PROJECT : AT6
Quanta Computer Inc.

Size	Document Number	Rev
Custom	CPU_CORE(MAX8771)	1A
Date:	Monday, May 22, 2006	Sheet 44 of 45

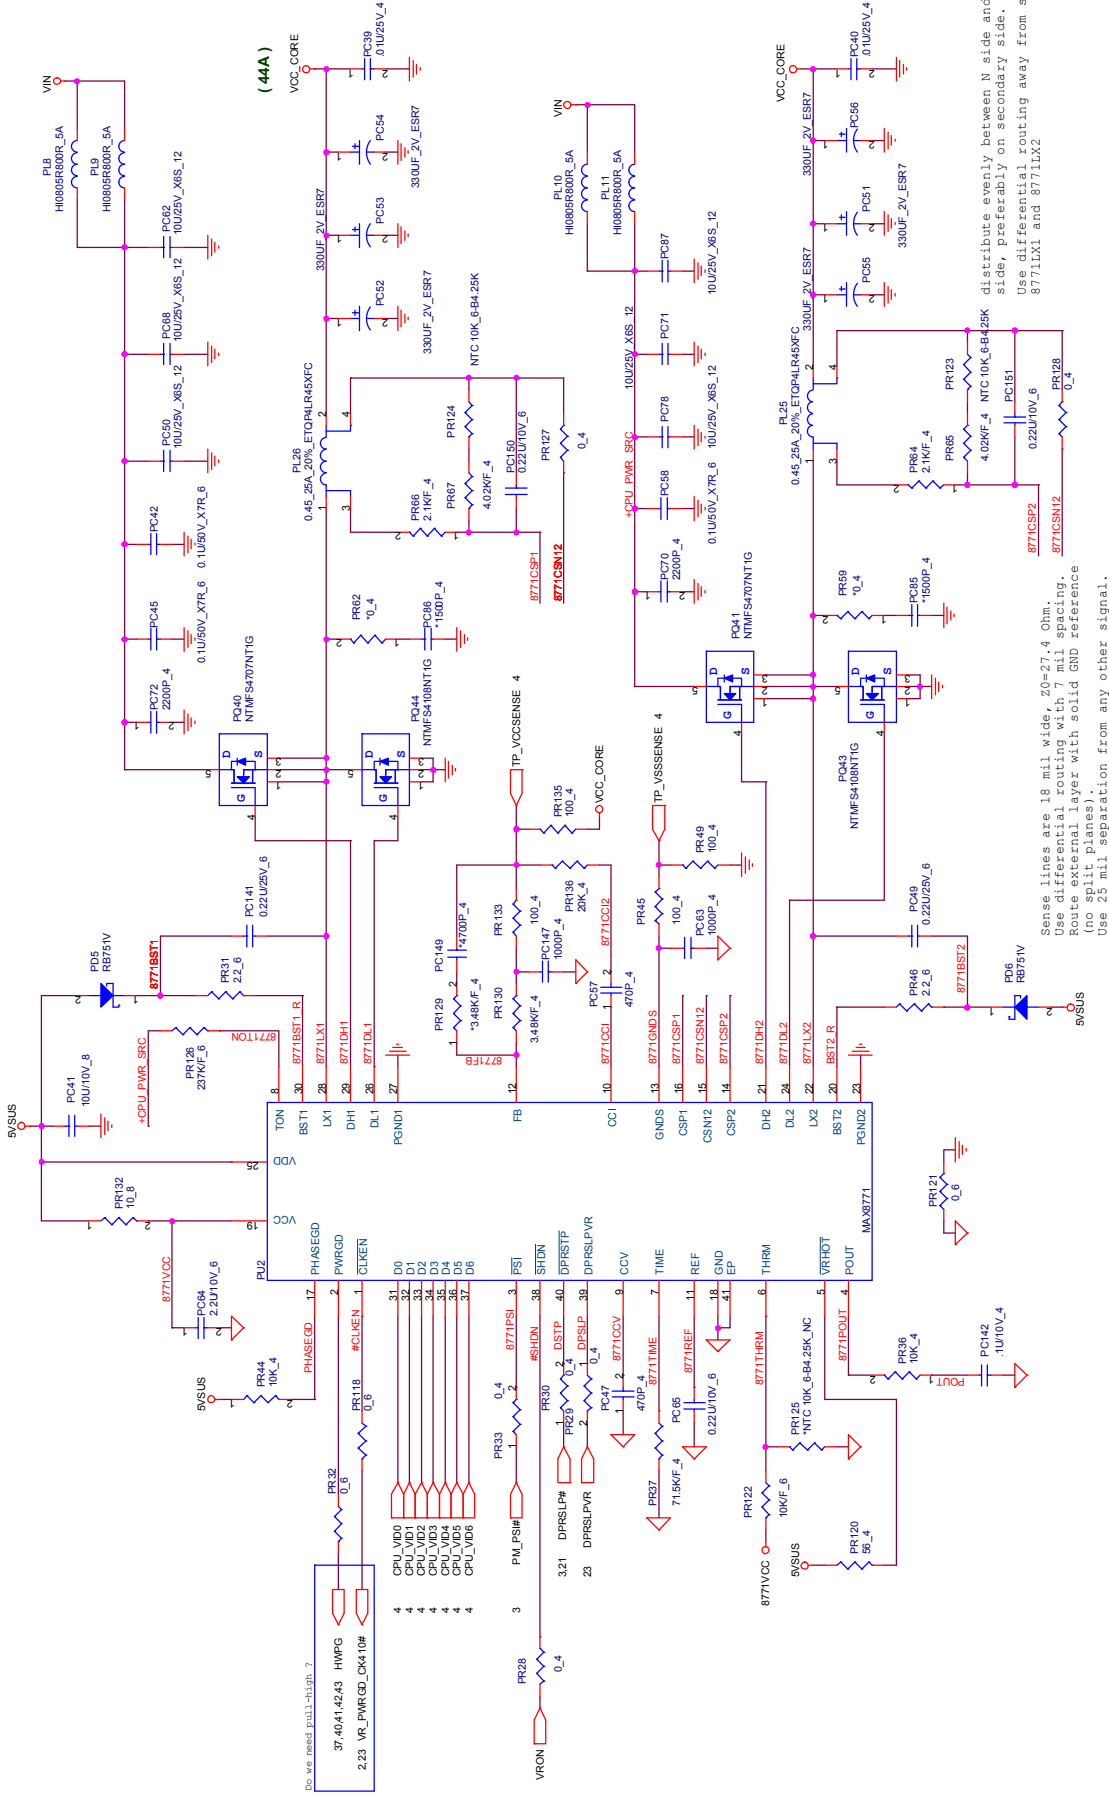
Add layout note on pins 22 and 28 of MAX8771 controller. These nets have large voltage swings. Need to route them away from the sensitive areas that are trying to detect small changes in voltage, such as the voltage sense VccSense lines.
